Applicant Responses to Select Public Comments on the Draft Proposed Order

Boardman to Hemingway Transmission Line Project
Idaho Power's Responses to Public Comments Received by ODOE on the Draft Proposed Order
October 16, 2019

**Attachment 4: Boardman to Hemingway Transmission Line
 DPO Comment, Applicant Responses, Department Response in Proposed Order Crosswalk Tables**

Figure 5 – Viewshed of ML 6/1 - 6/3, 7/1 - 7/4, 8/1 - 8/2

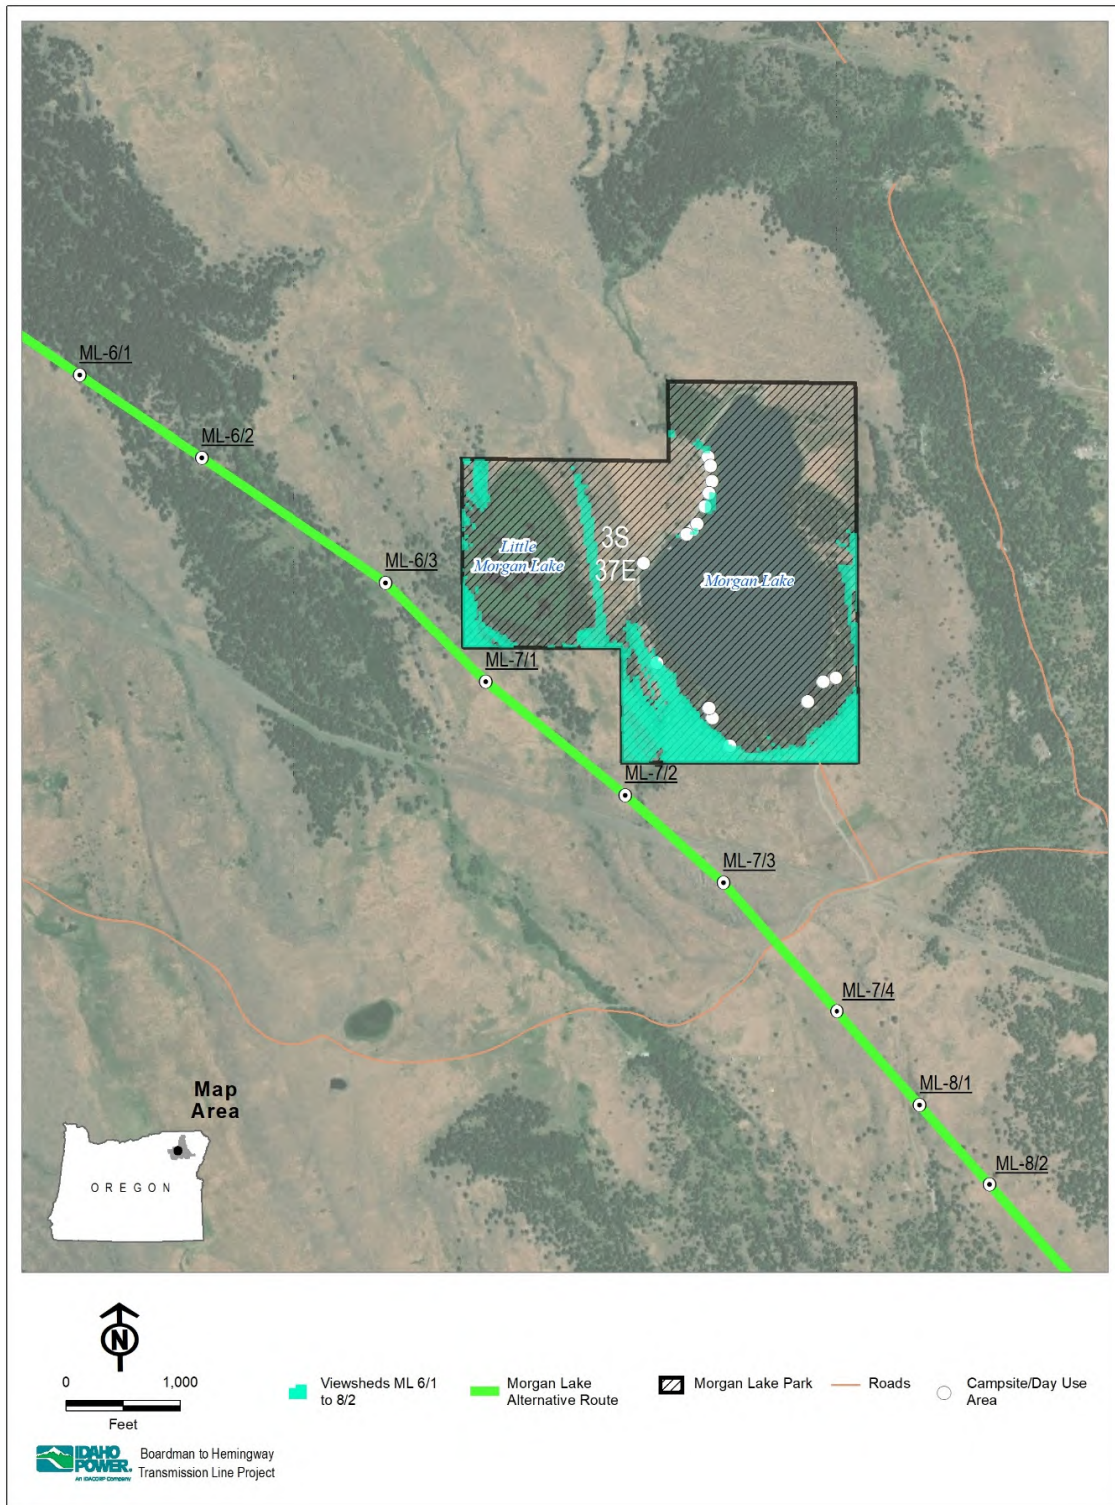
Figures 5 and 6 show the modeled viewshed accounting for trees surrounding Morgan Lake and Little Morgan Lake for the following towers nearest to Morgan Lake Park: ML 6/1, ML 6/2, ML 6/3, ML 7/1, ML 7/2, ML 7/3, ML 7/4, ML 8/1, and ML 8/2. Light green shading depicts areas within the Morgan Lake Park boundary where at least some portion of one of the above listed transmission towers would be visible.

Figure 3 – Viewshed of ML 8/2

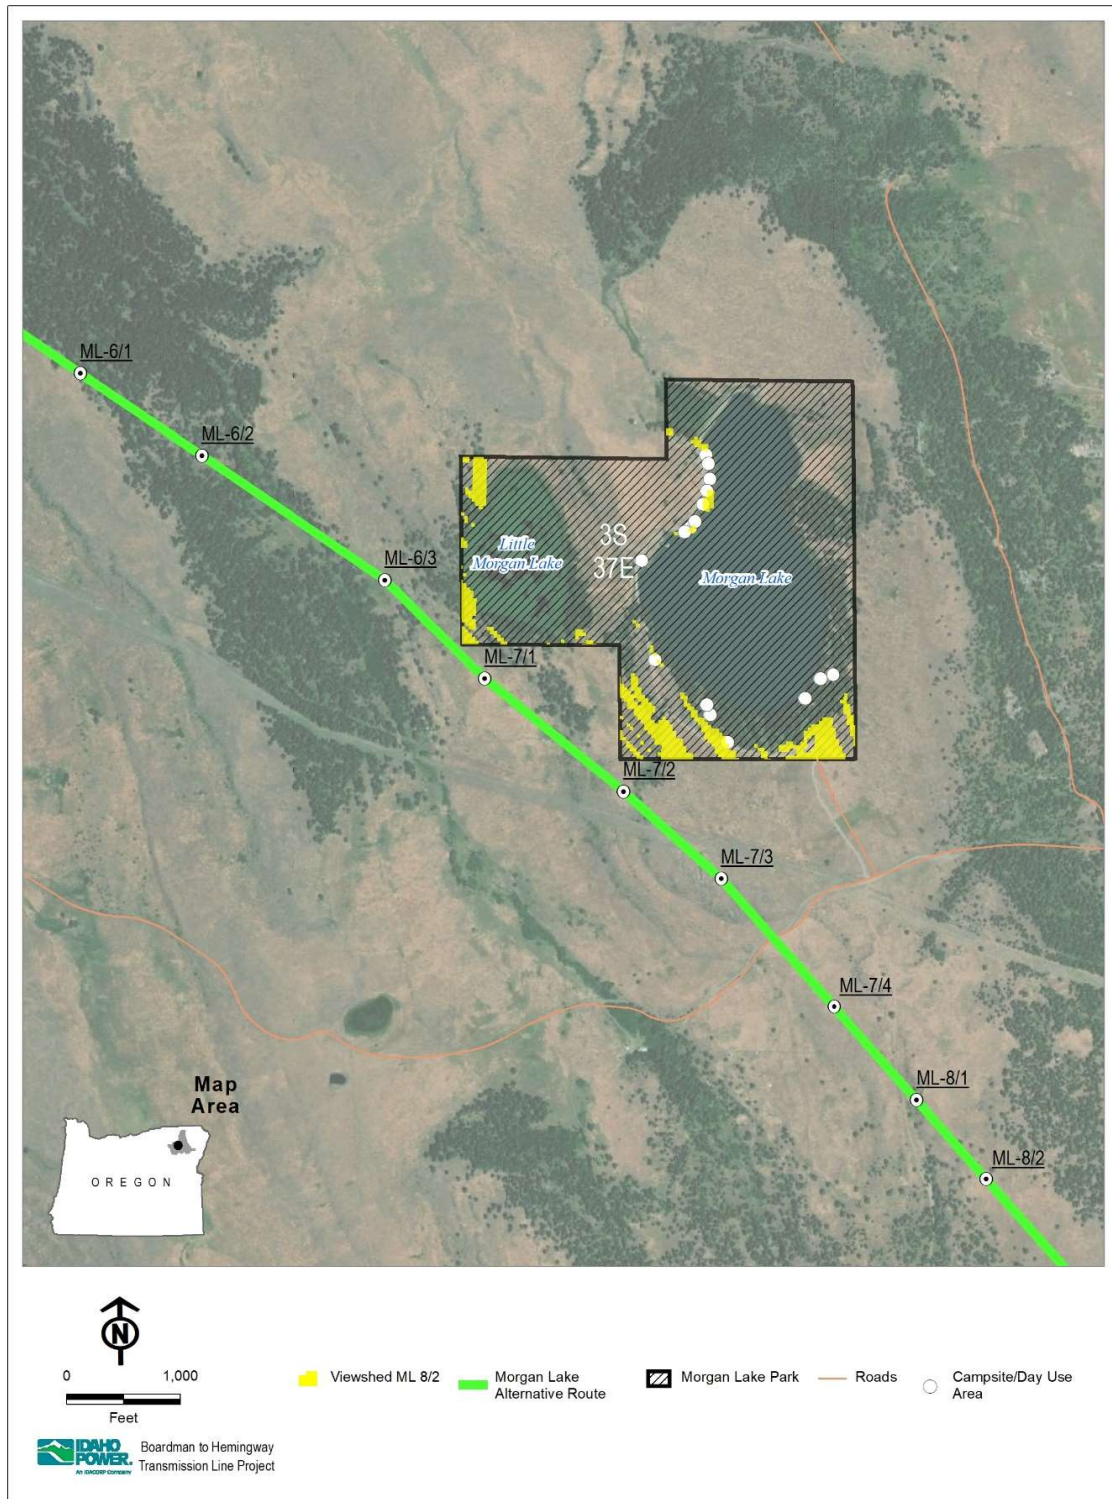
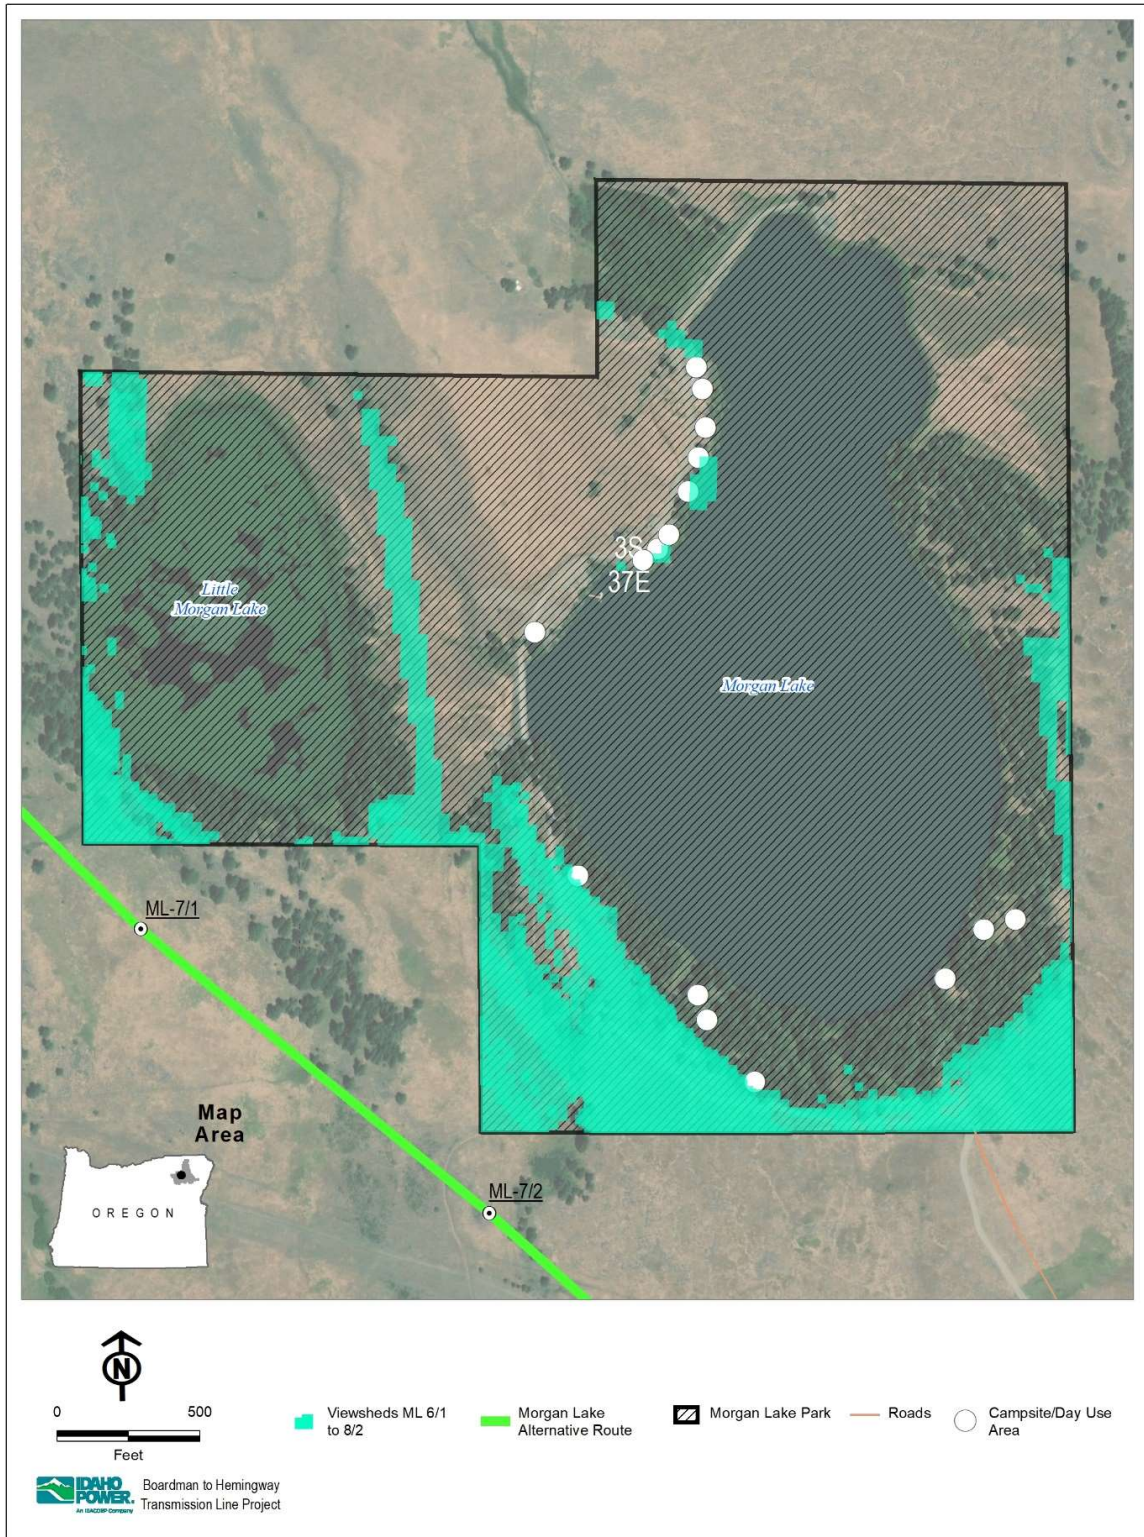
Around Morgan Lake, vegetation would effectively screen views of the transmission towers except for a few discrete locations along the western shore. No towers would be visible from the floating dock (see Figure 3 and Figure 8). Towers would not be visible from the campsites themselves along the southern shore of Morgan Lake, although the towers would be visible from the campsite parking areas.

Figure 5 – Viewshed of ML 6/1 - 6/3, 7/1 - 7/4, 8/1 - 8/2

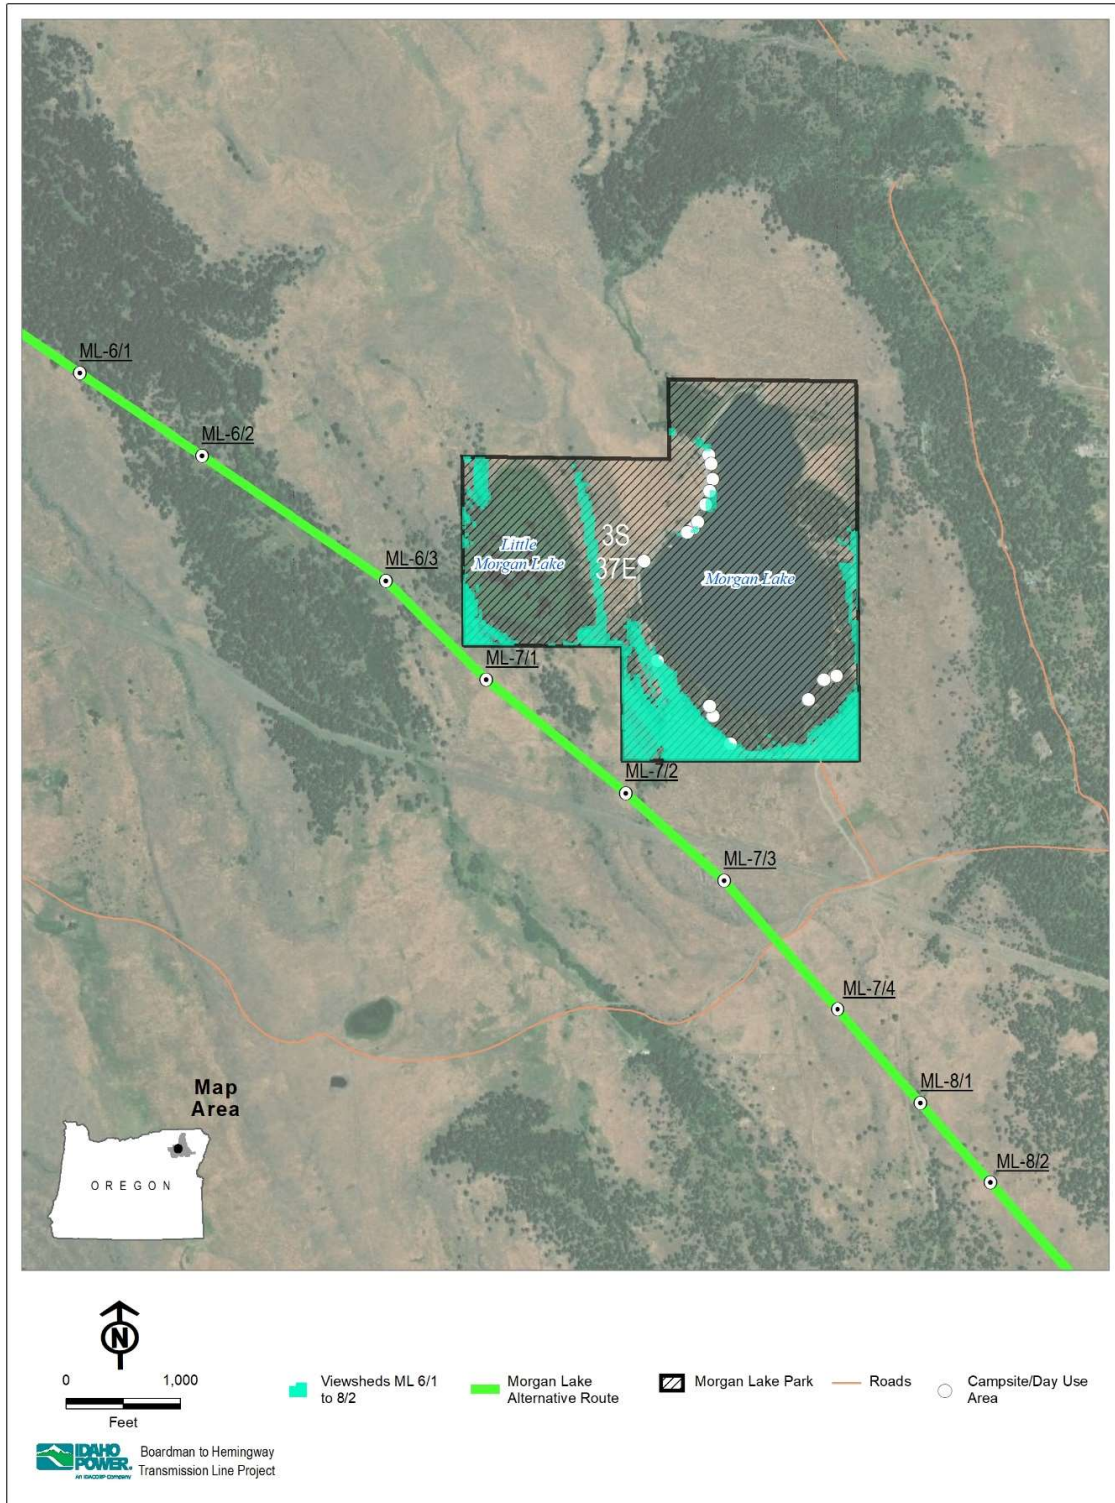
Figures 5 and 6 show the modeled viewshed accounting for trees surrounding Morgan Lake and Little Morgan Lake for the following towers nearest to Morgan Lake Park: ML 6/1, ML 6/2, ML 6/3, ML 7/1, ML 7/2, ML 7/3, ML 7/4, ML 8/1, and ML 8/2. Light green shading depicts areas within the Morgan Lake Park boundary where at least some portion of one of the above listed transmission towers would be visible.
